ADDENDUM NO. 3

PROJECT: FAIRFIELD MIDDLE SCHOOL, COURT YARDS, STOREFRONT WINDOWS & DOORS INSTALLATION
IFB 2223-10

DATE: April 21, 2023

PARTIAL STOREFRONT ELEVATION
VIEWED FROM COURT YARD
NTS

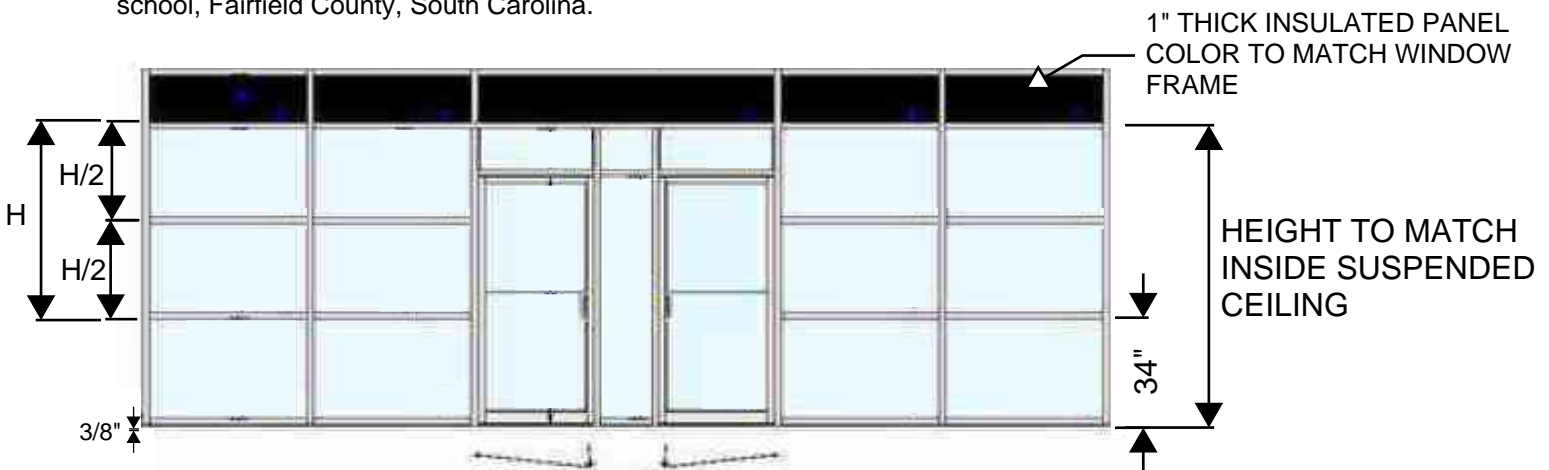
Doors shall open into the court yard and be furnished with a push bar (not an emergency push bar) on the corridor side and offset pull handle on the court yard side.
